**ADDENDUM 1 – JOB 1**

TO: All prospective bidders on Project SU-IM-8-984(153)156, Job No. 1 scheduled for the November 13, 2020 bid opening.

PROJECT INFORMATION		
<b>Project:</b>	SU-IM-8-984(153)156	<b>PCN:</b> 21564
<b>Location:</b>	Fargo, ND	
<b>Date:</b>	11/03/2020	<b>Lead Designer:</b> Scott Middaugh
<b>Bid Opening Date:</b>	Nov 13, 2020	<b>JOB#:</b> 1 <b>Addendum#:</b> 1

Revised	11/4/20	STATE	PROJECT NUMBER	SECTION NO.	SHEET NO.
		ND	SU-8-984(153)156	170	11

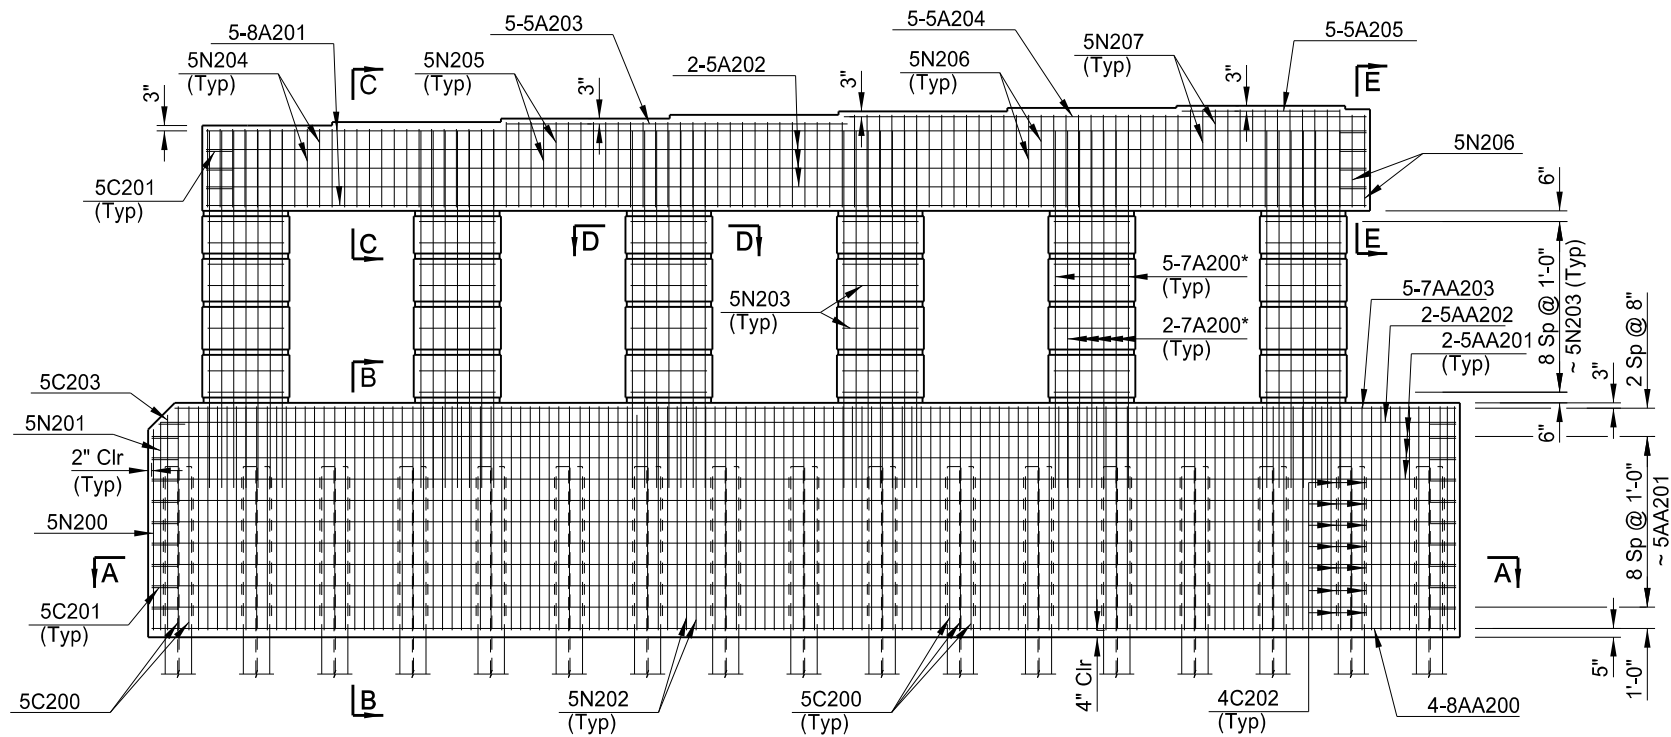
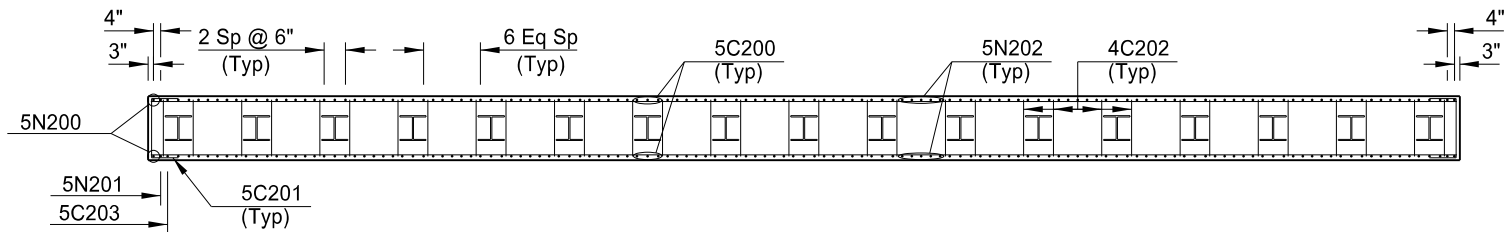
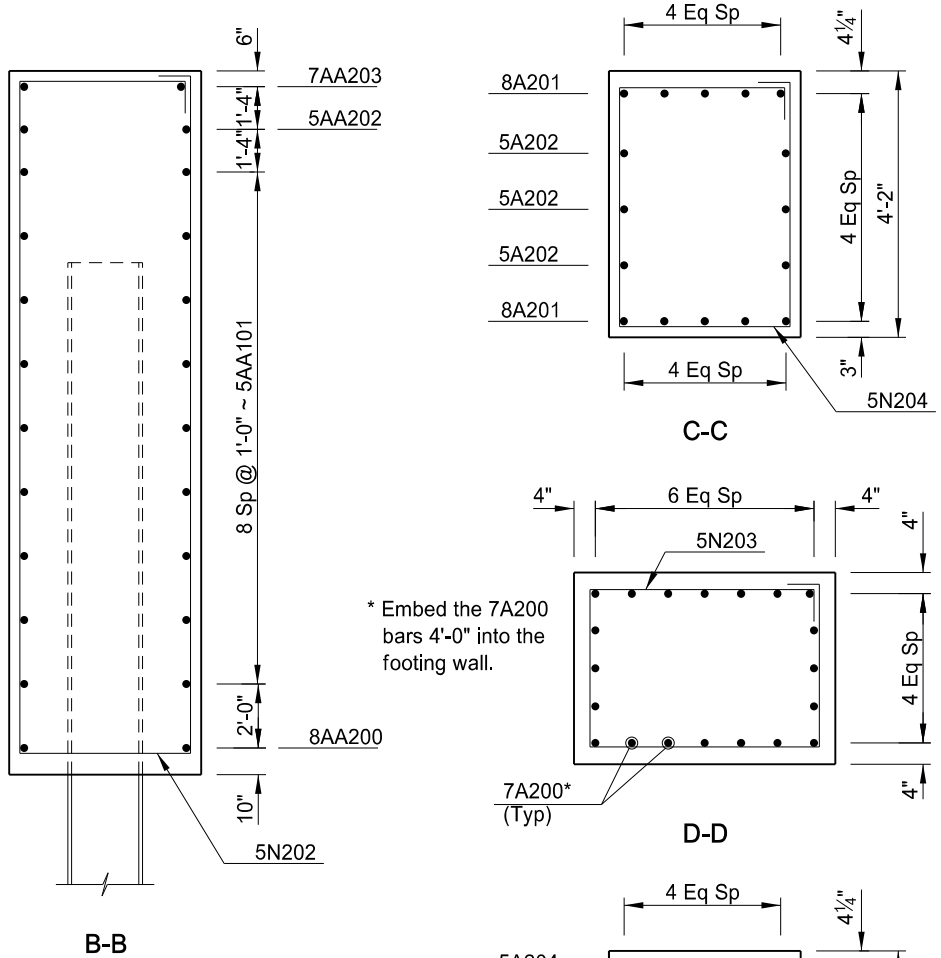
612	0115	REINFORCING STEEL - GRADE 60	LBS	32,621	33,647
		622	0070	STEEL PILING HP 14X102	LF	1,540	1,955
		<ul style="list-style-type: none"><li>Revised Screed Elevations.</li></ul>					
170	5	Added pier piling and revised spacing. Revised pile coordinates for Pier 2.					
170	10	Added pier piling and revised spacing. Pile embedment increased					
170	11	Changed 7A201 bars to 8A201 bars. Added pier piling. Pile cap reinforcing revised. Added 5C203 bar. Revised 5N201 bar. Quantity and spacing revised for 5N202 and 5C200 bars. Revised quantity for 4C202 bars. Pile embedment increased					
170	12	Added temporary bracing to Abutment 3 Revised camber diagram and deflection table.					
170	16	Revised detail callouts in Note 1.					
170	22	Revised table based on Sheet 11 revisions.					
170	30	Revised C-C to show formliner insets in the barrier.					
170	33	Revised deck edge on Pedestrian Wall detail. Revised deck edge on Edge Barrier detail.
